PCN-8-2019

Transition of F series Molded J-Lead MnO₂ Tantalum Chip from Adogawa, Japan to El Salvador

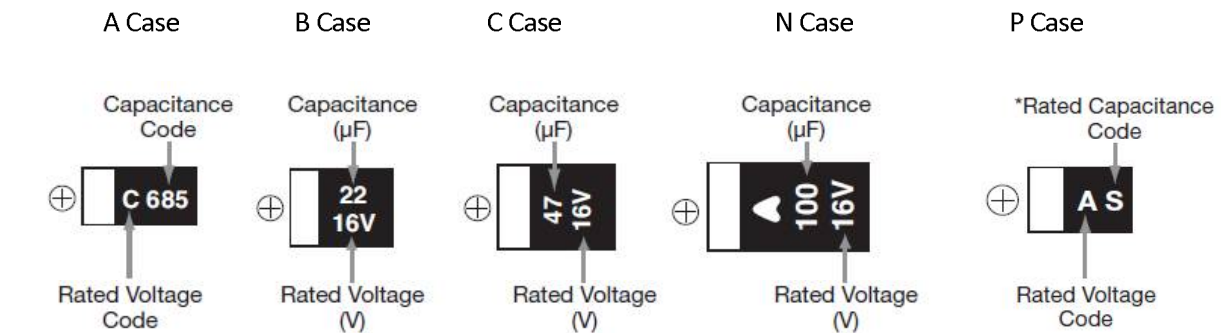
El Salvador currently manufactures automotive grade TAJ EIA Standard and TPS Low ESR molded tantalum chip. A qualification report will be issued for each series once manufacturing commences in El Salvador. The automotive F series Molded J-Lead MnO₂ Tantalum Chip series are as follows:
